Notice of Discontinuation
WM03PCT2S614
Print Mark Reader

Discontinued product: WM03PCT2S614

Recommended successor product: P1MW001

Discontinuation date: 30.04.2027

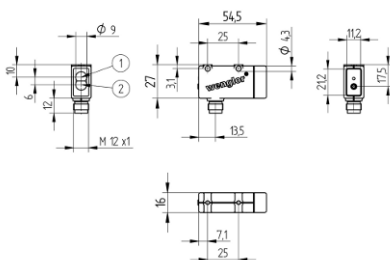
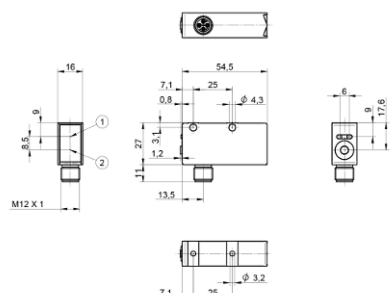
The successor product has an IO-Link interface instead of RS-232.

For the successor product, the on- and off-delay can be parameterized via IO-Link.
